DEVELOPMENT REVIEW BOARD
SUPPLEMENTAL SUBMITTAL

PROJECT NO. PR-2021-005459
Application No. SD-2021-00163 SI-2021-01248

**RE: PR-2021-005459 RESPONSE TO DRB COMMENTS
LOT 1A BLOCK 2 & LOT 2-A-1 BLOCK 2 SUNPORT PARK
2900 TRANSPORT ST NE**

DRAWING TITLE
BUILDING 100 COLOR ELEVATIONS

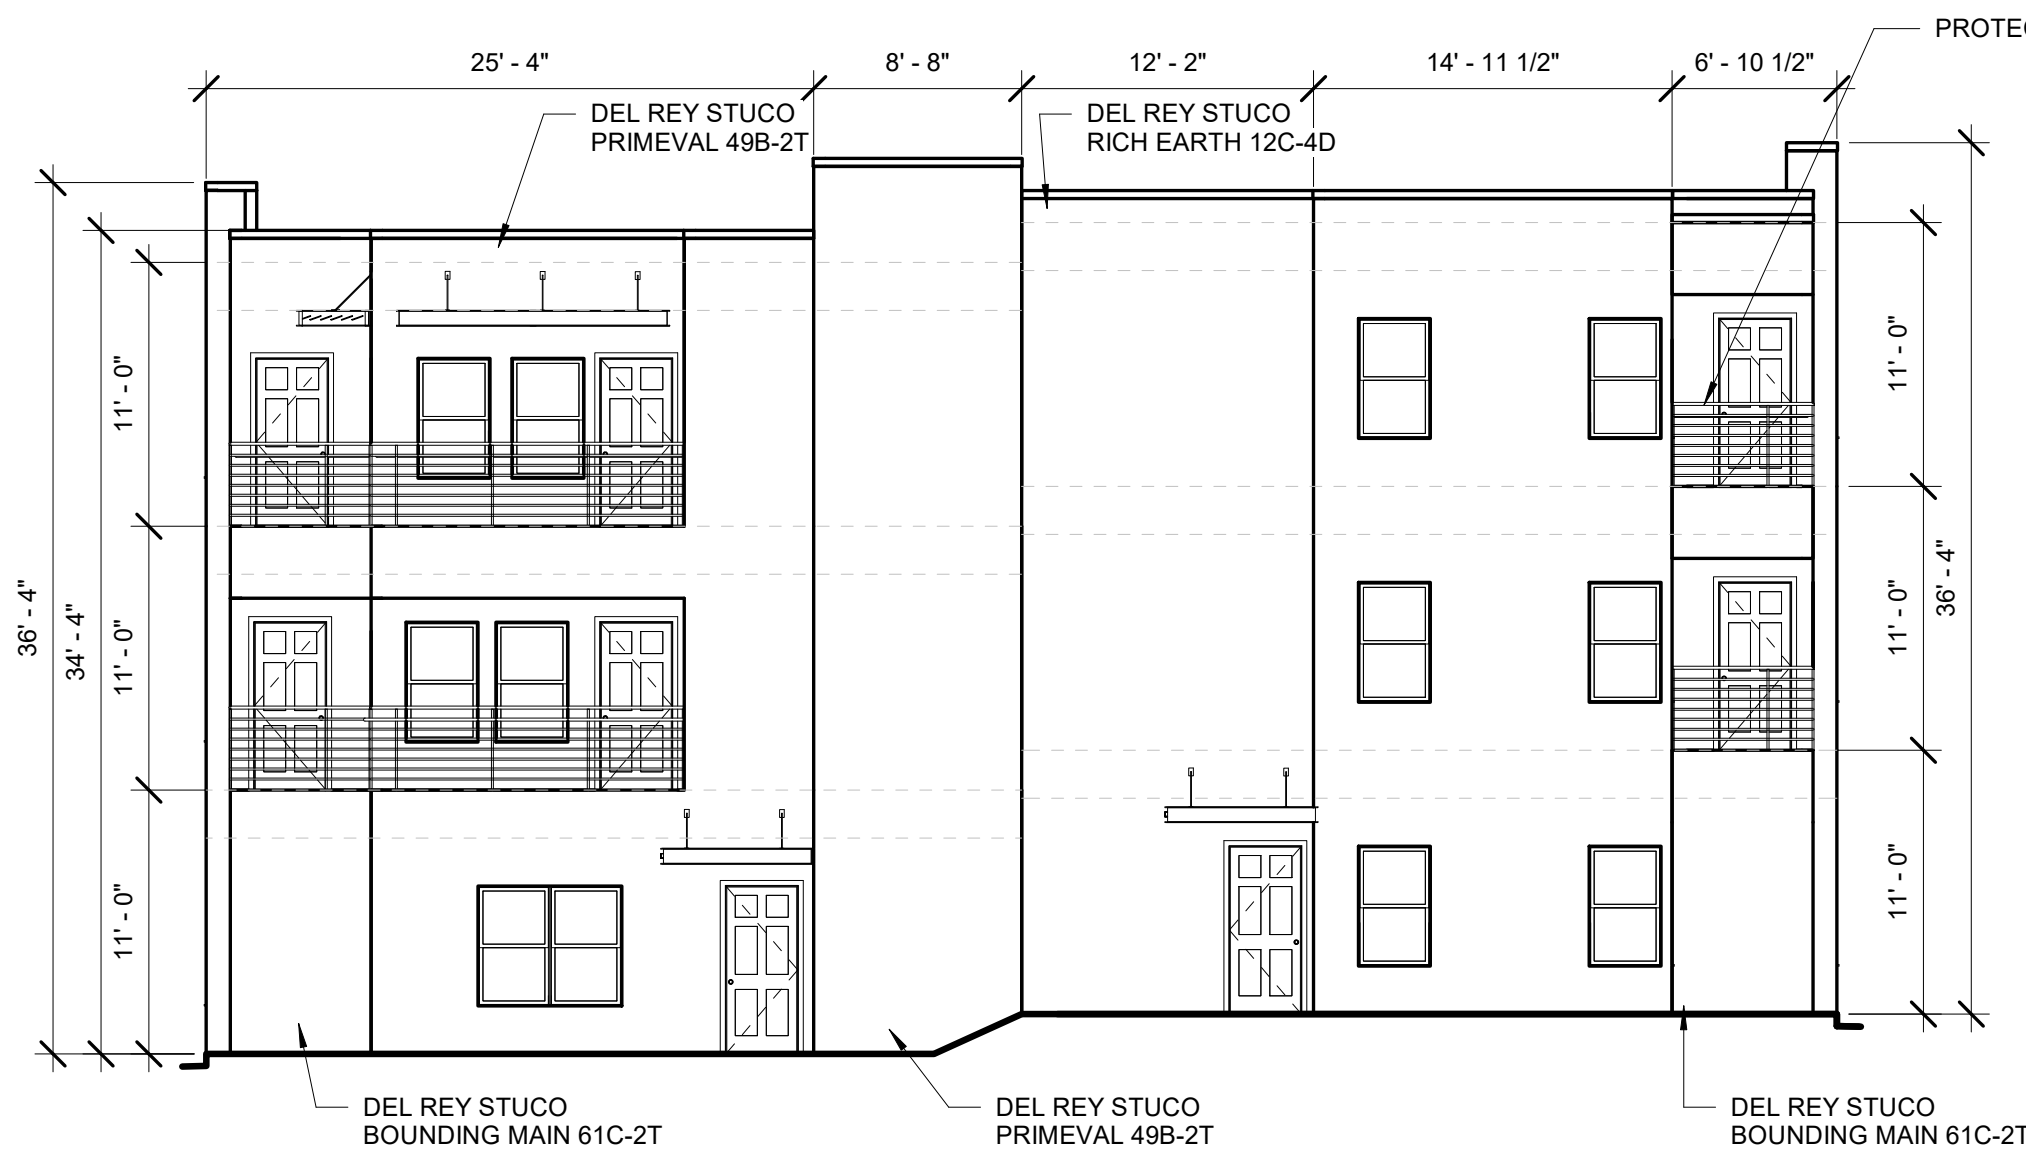
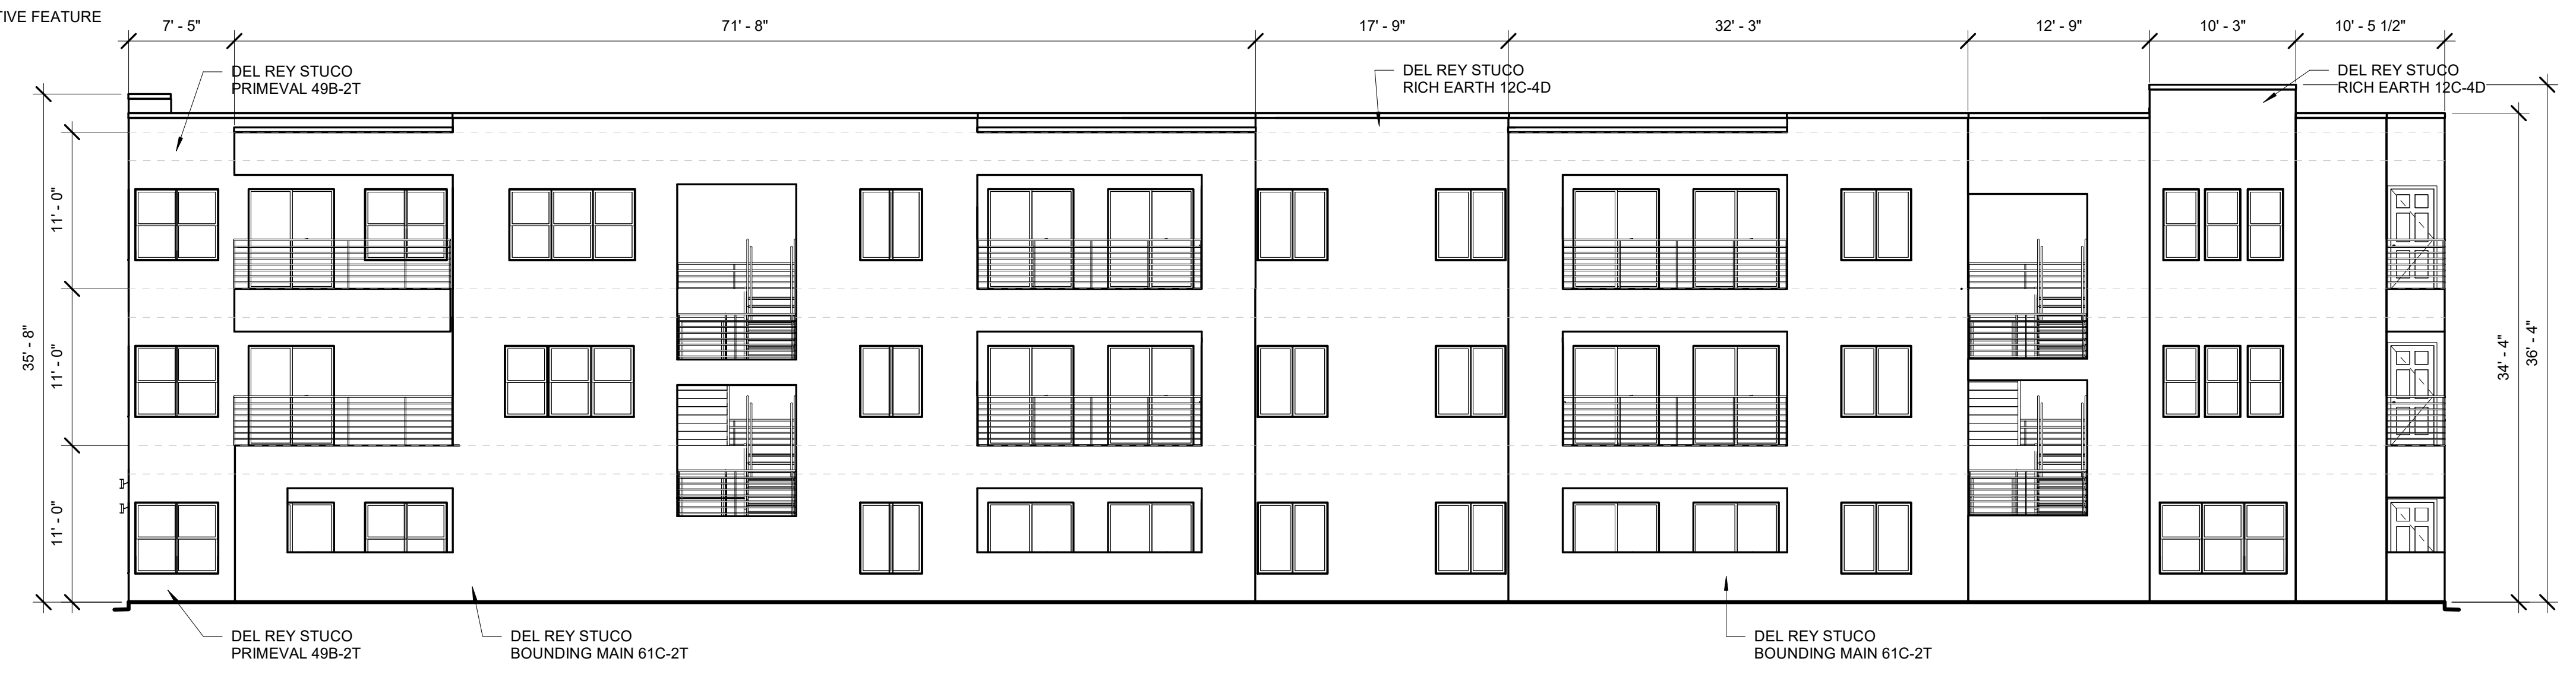
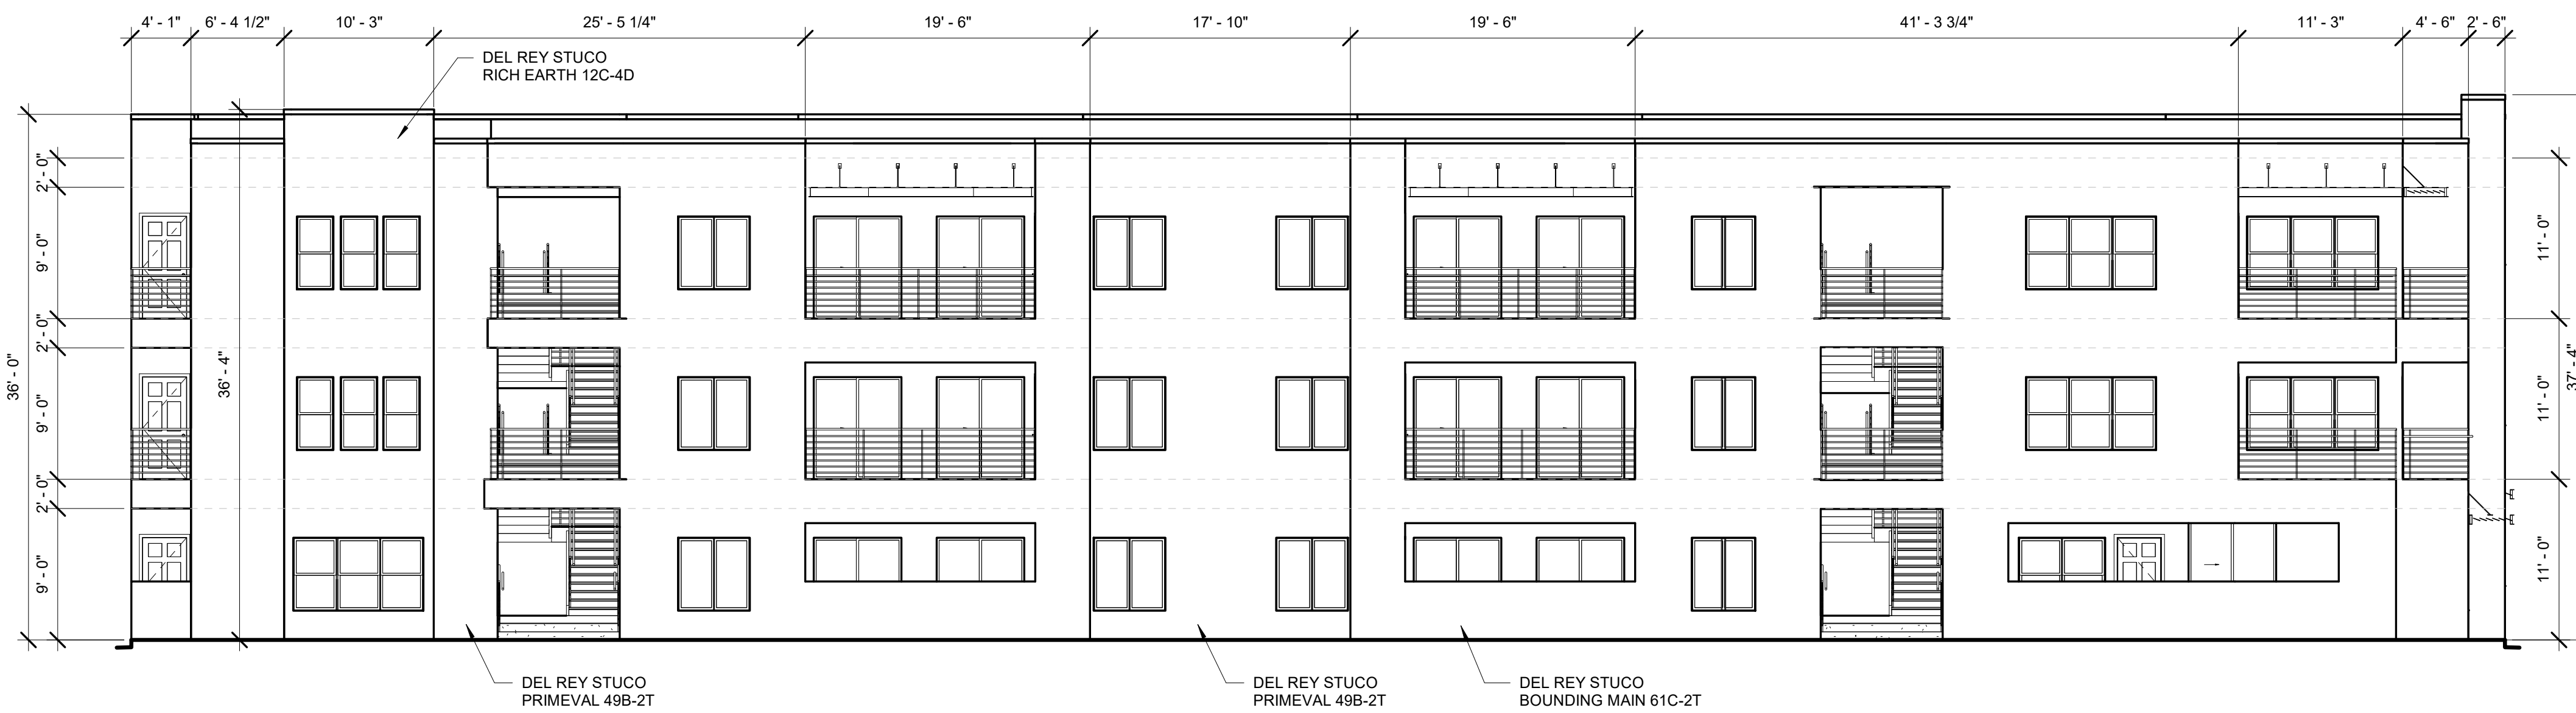
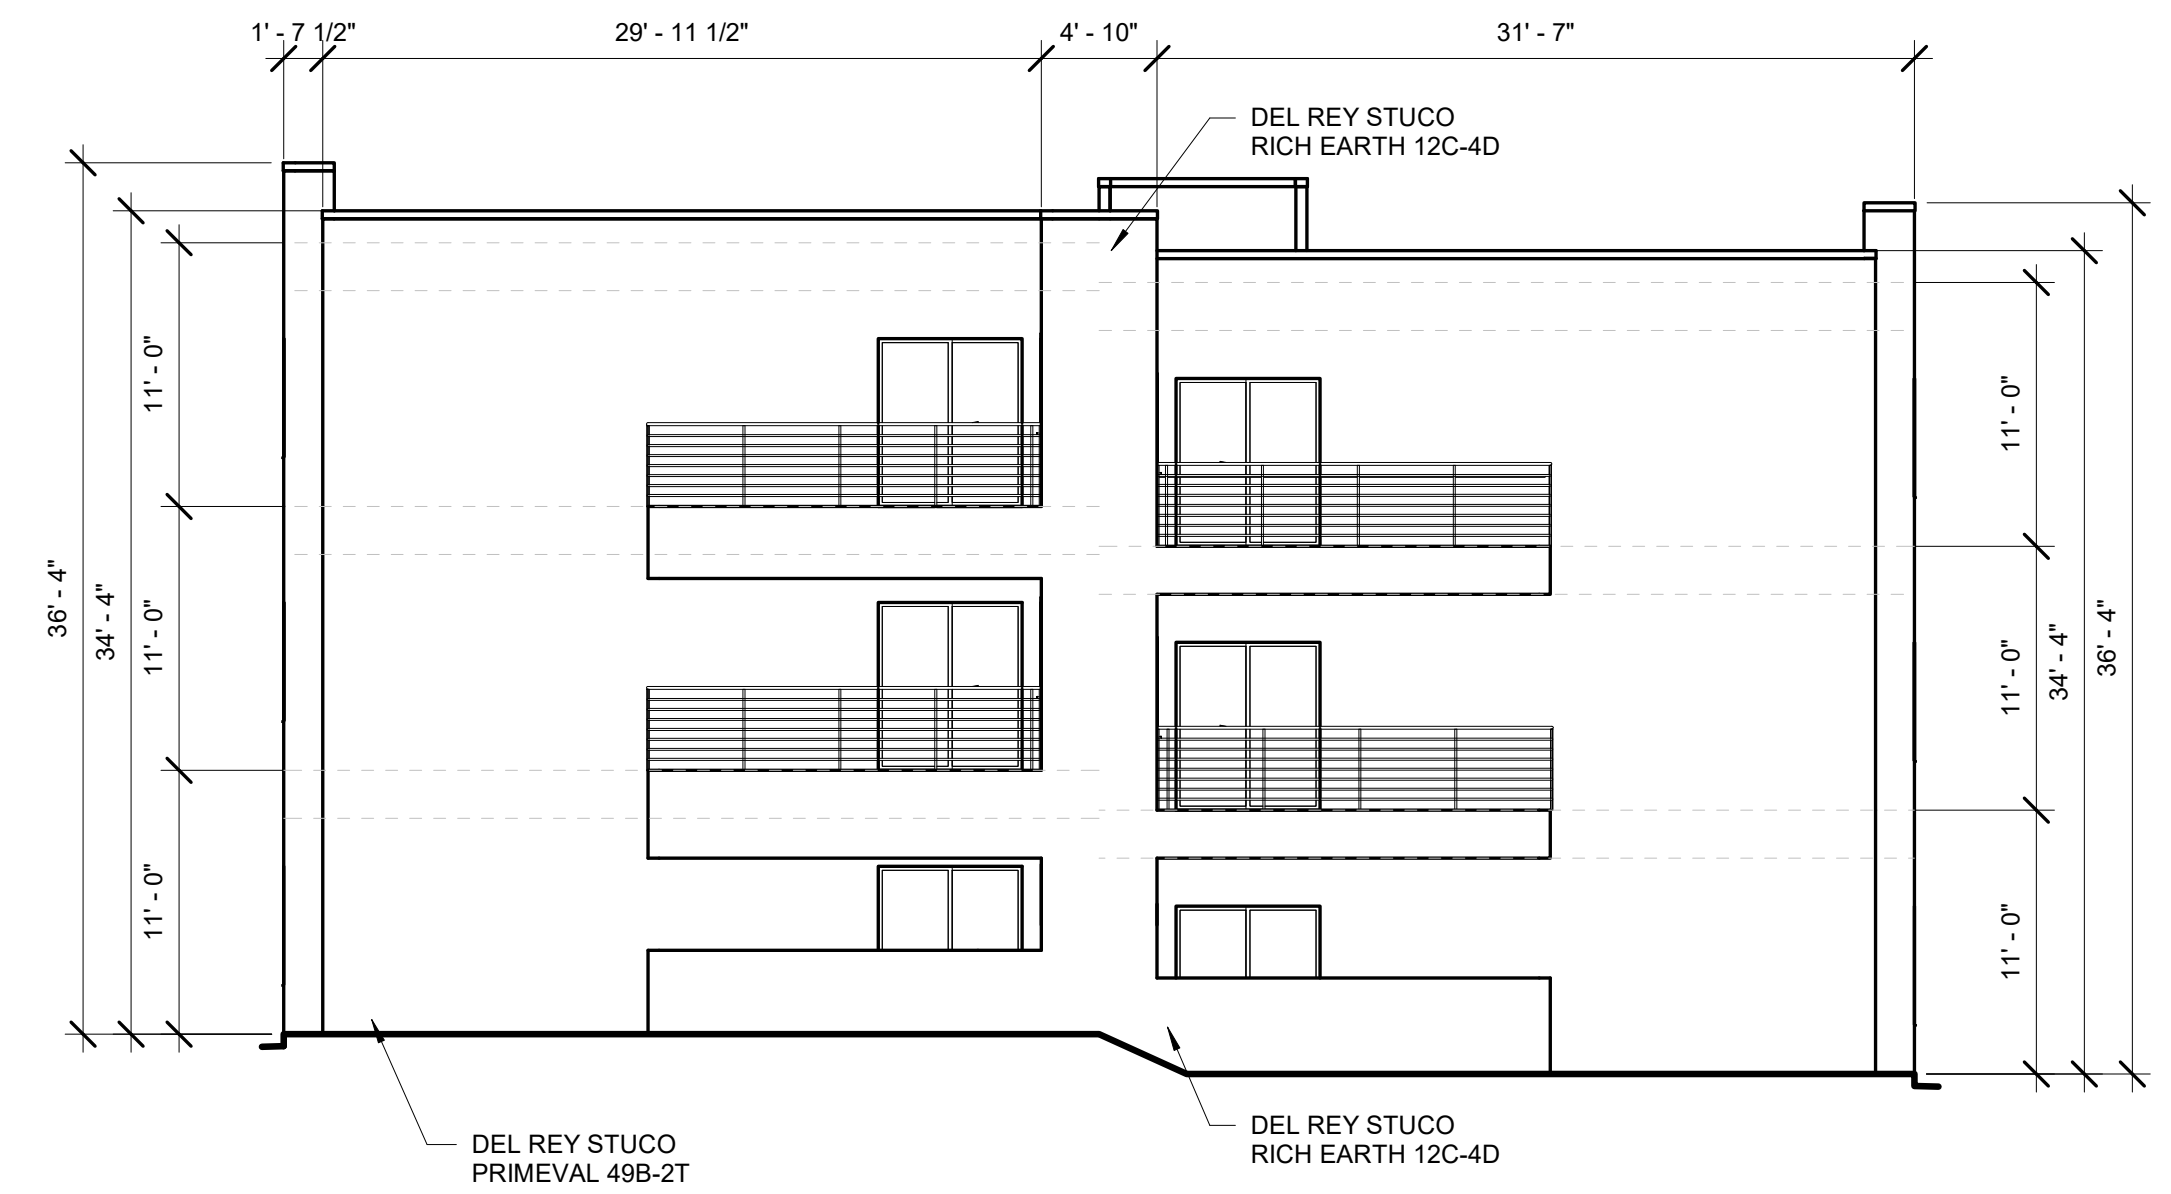
11. The applicant must confirm that the Façade Design requirements of 5-11(D) of the 2020 IDO are being met in a comment response letter and how they are being met. Please note requirement 5-11(D)(1) requiring that entrances be emphasized and provide weather protection. Also, note 5-11(D)(2)(a) Windows requiring heat mitigation features for western windows and recessed or framed windows. Please also note: 5-11(D)(2)(b)(4) Articulation requiring that balcony massing, material, or color shall vary to create visual interest.

RESPONSE: Shade awning callouts added to building elevations, most entrances to the units are off of breezeways. Note added to building elevations to recess windows 2", shade awnings provided at windows on upper floors. Balconies provide shade to glazing below them. Balconies vary in massing and material, reference building elevations included in this resubmittal.
